SUBDIVISION REPORT - CONCEPT/DEVELOPMENT PLAN

▶ **FILE #:** 12-SE-23-C **AGENDA ITEM #:** 36
12-E-23-DP **AGENDA DATE:** 2/8/2024

▶ **SUBDIVISION:** BOTEZAT PROPERTY - MILLERTOWN PIKE

▶ **PROPOSED USE:** Detached residential subdivision

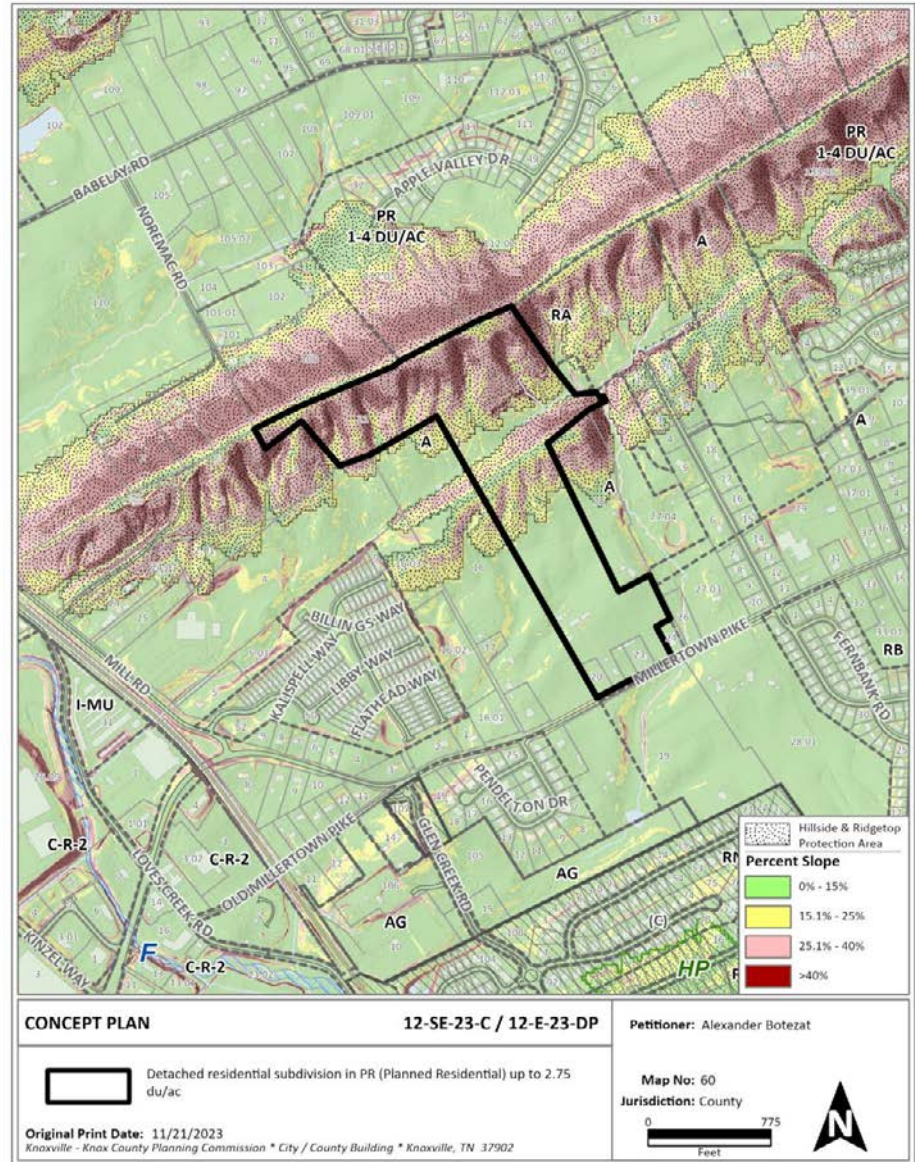
There are 27.4 acres of this 44.9-acre site in the HP (Hillside Protection) area. The slope analysis recommends limiting disturbance in the HP area to 8.7 acres (31.8 percent). This proposal disturbs approximately 10.6 acres (38.7 percent) of the HP area. The upper slopes of McAnnally Ridge remain undisturbed.

CONCEPT PLAN FOR
BOTEZAT PROPERTY-MILLERTOWN PIKE
TAX MAP 60 PARCELS 20, 21, 22 & 23
6TH CIVIL DISTRICT, KNOX COUNTY, TENNESSEE

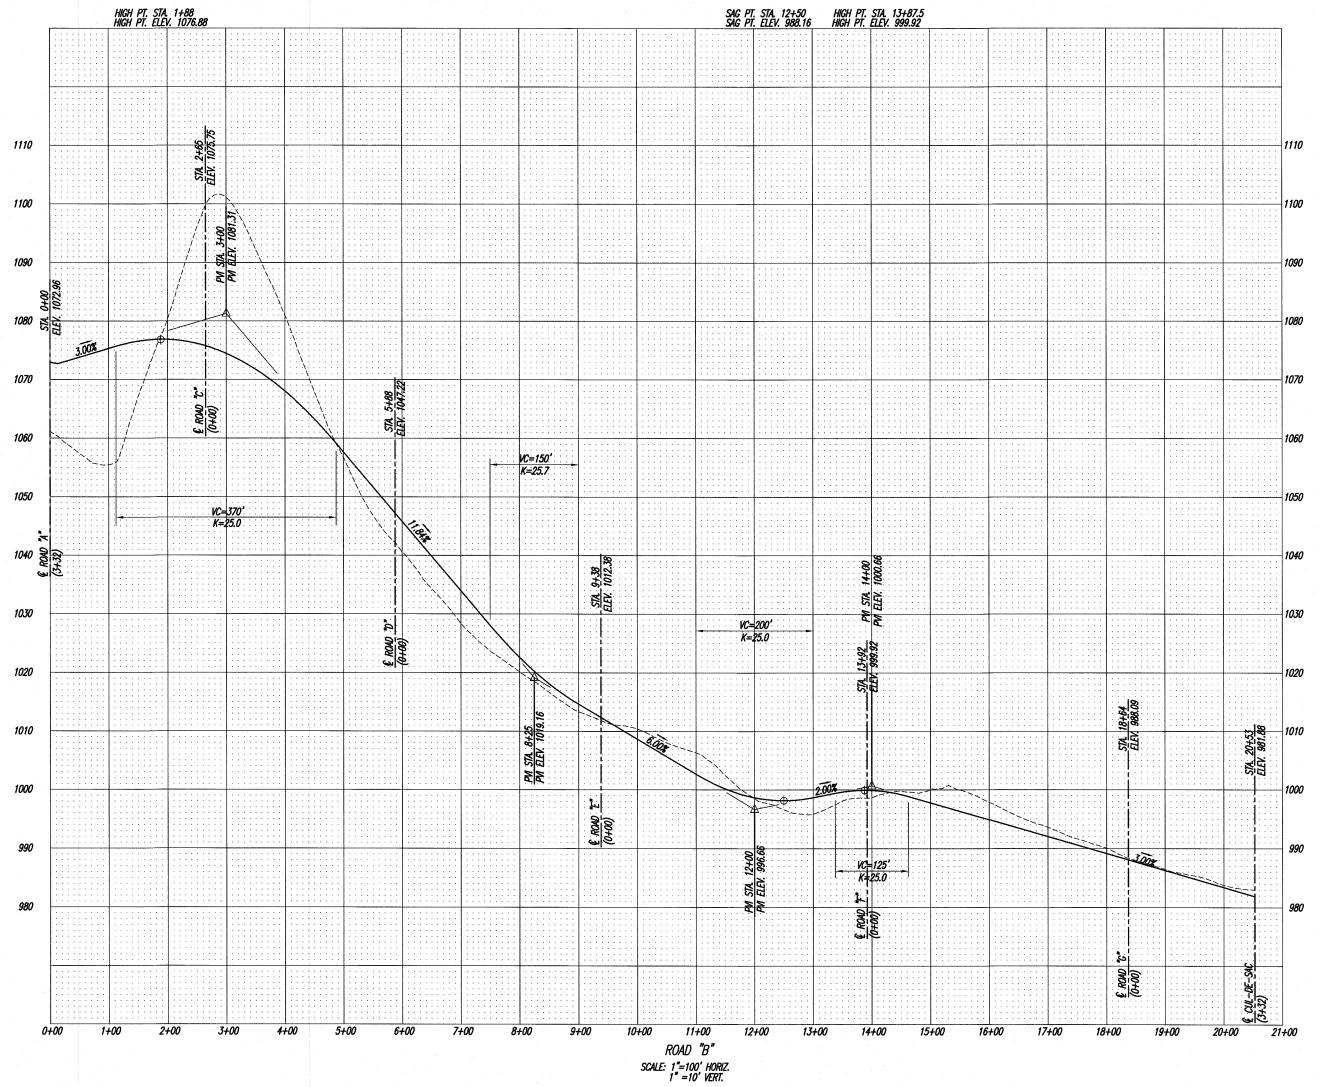
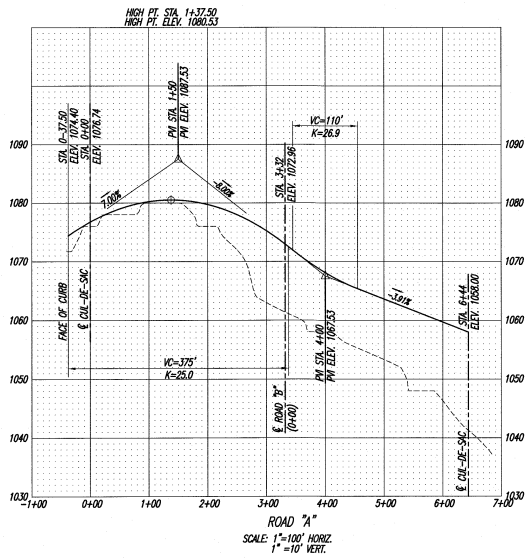
1) Reduce the minimum horizontal curve radius from 250 ft to 150 ft on Road 'B' at STA 9+50.

- 2) Reduce the minimum horizontal curve radius from 250 ft to 150 ft on Road 'B' at STA 12+50.
- 3) Reduce the minimum horizontal curve radius from 250 ft to 150 ft on Road 'B' at STA 17+00.

- 4) Obtaining 250 ft of intersection sight distance within the right-of-way at all internal intersections or providing a 250-ft sight distance easement across lots and/or common area per the requirements of Knox County Engineering and Public Works during the design plan phase. Any driveways on these lots must be located outside the sight distance easement and shown on the plat, or the driveways must have a depth of 20 ft beyond the sight distance easement if they cannot be located outside the sight distance easement.

- 5) Obtaining 400 ft of intersection sight distance entirely within the Millertown Pike right-of-way or providing a 400-ft sight distance easement across lots and/or common area per the requirements of Knox County Engineering and Public Works during the design plan phase.

- 6) Providing access for 5713 Millertown Pike (parcel 060-024) to the Road 'B' cul-de-sac as shown on the concept plan.
- 7) Providing a temporary turnaround at the eastern terminus of Road 'E' and Road 'F' per the requirements of Knox County Engineering and Public Works during the design plan phase. The 50 ft public right-of-way shall be extended to the property boundary as shown on the concept plan with notification of future connection provided per section 3.04.C.2 of the Subdivision Regulations. The temporary turnaround area outside the 50 ft right-of-way may be in an easement with the approval of Knox County Engineering and Public Works. The easement or right-of-way for the temporary turnaround can be eliminated if the public road is extended and the turnaround is no longer required.

- 9) Providing a maximum intersection grade of 2 percent on Road 'G' at Millertown Pike.
- 10) The driveway slope within the right-of-way shall not exceed 2 percent for lots 78-90 for the future installation of sidewalks.

- 11) The grading within the HP (Hillside Protection) area, north of Road 'A', shall be limited to what is proposed on the concept plan or otherwise in conformance with the zoning condition limiting disturbance on slopes of 25

12) Providing a note on the final plat that all lots shall have vehicular access from internal roads, except for lot 89.

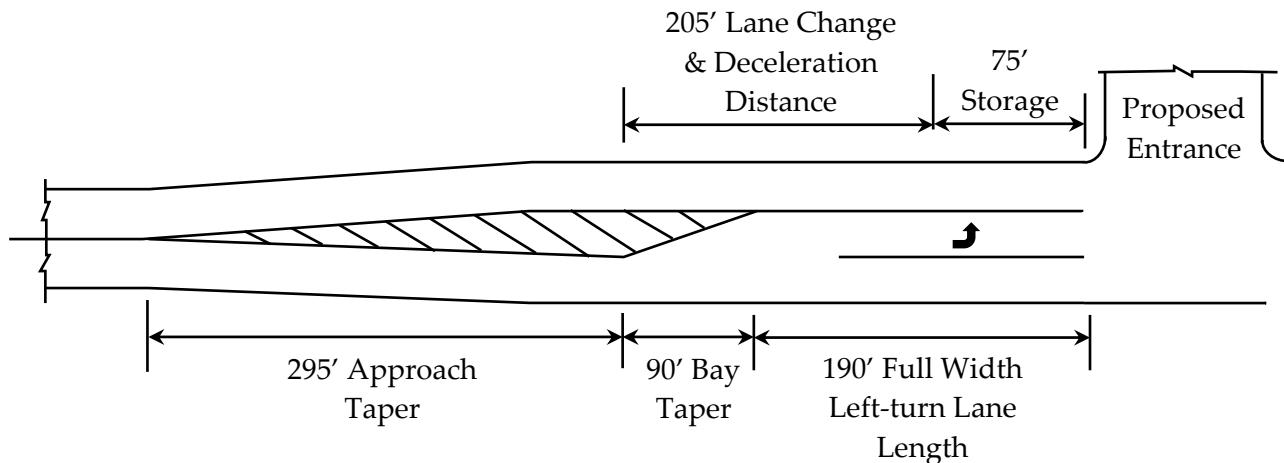
According to TDOT's Highway System Access Manual, the functional area for an exclusive turn lane includes the "lane change and deceleration distance" and the storage length. The bay taper length is included in the lane change and deceleration distance, as shown in the following TDOT diagram:

The lane change and deceleration distance is a function of vehicle speeds, and in constrained conditions, the designer can assume some deceleration before the lane change. A speed of up to 10 mph less than the design speed can be assumed in these conditions. For this proposed eastbound left-turn lane on Millertown Pike, a vehicle

speed of 35 mph (assuming a design speed of 45 mph) was used in the calculations. Based on this assumption, the calculated and recommended lengths for a proposed 11-foot wide left-turn lane include a bay taper length of 90 feet, a lane change and deceleration distance of 205 feet, and a storage length of 75 feet. The largest 95th percentile vehicle queue length for the eastbound left-turn lane on Millertown Pike was calculated to be 73 feet in the PM peak hour in 2027 and would be contained within a storage length of 75 feet. With a 90-foot bay taper, the full-width left-turn lane will be 190 feet long. Based on a posted speed limit of 40 mph, the approach taper should be 295 feet. The following diagram shows the recommended lengths for the turn lane at the Proposed Entrance. The approach taper on Millertown Pike on the east side approaching the intersection from the opposite side must also be 295 feet.

The eastbound left-turn lane pavement should be marked with a left-turn arrow, as shown in TDOT Standard Drawing T-M-4.

**Existing Driveway Entrance Walls at 5709
Millertown Pike and Vegetation along
Millertown Pike**

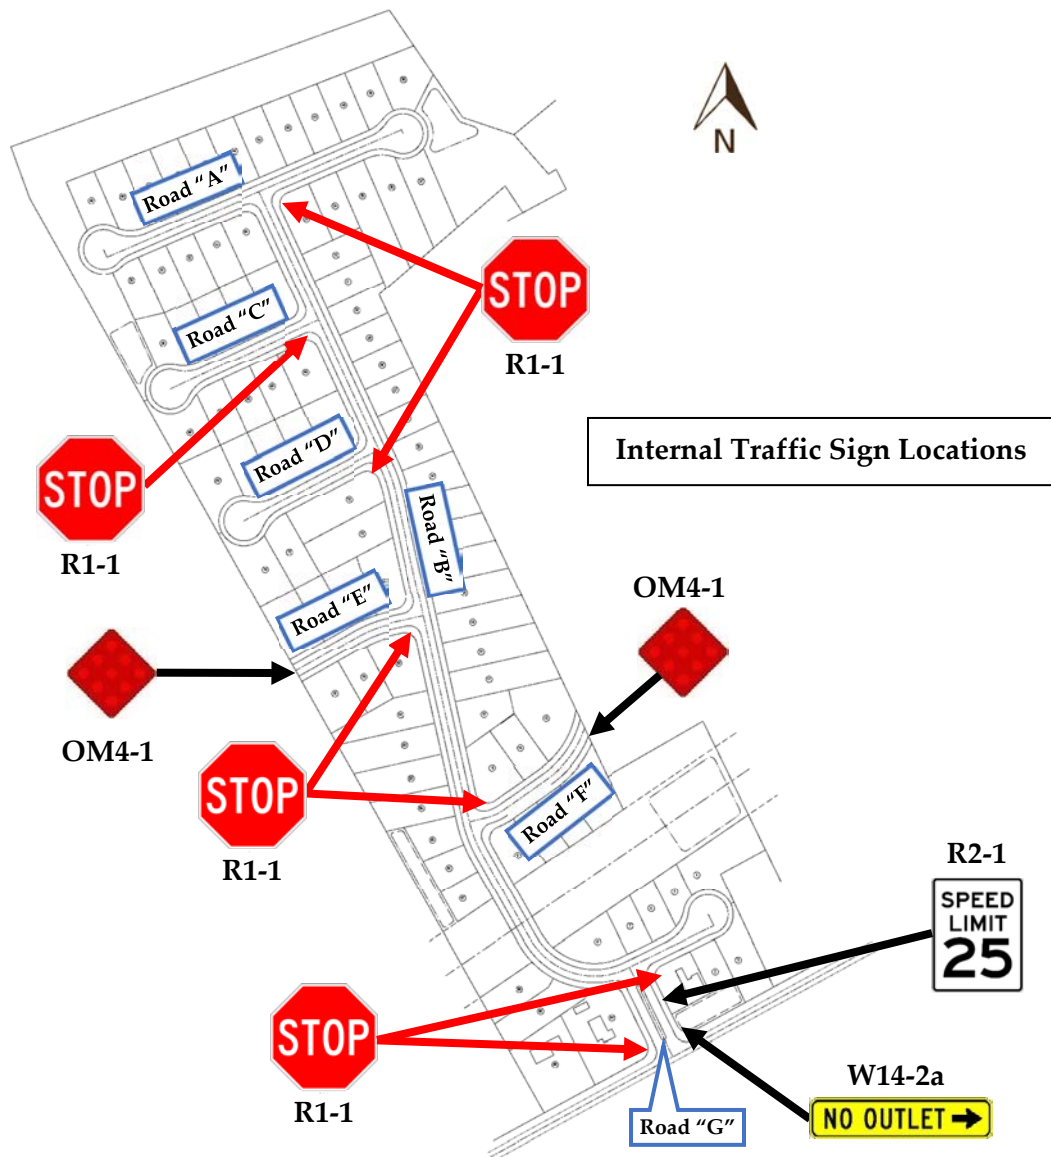
- 1d) Intersection sight distance at the Proposed Entrance at Millertown Pike must not be impacted by future landscaping or signage. Based on a posted speed limit of 40-mph on Millertown Pike, the required intersection sight distance is 400 feet for exiting left and right-turning vehicles. The site designer must verify that these distances will be available. The existing driveway entrance walls at 5709 Millertown Pike and the vegetation on

the north side of Millertown Pike along the development property's frontage will need to be removed to maximize the sight distance.
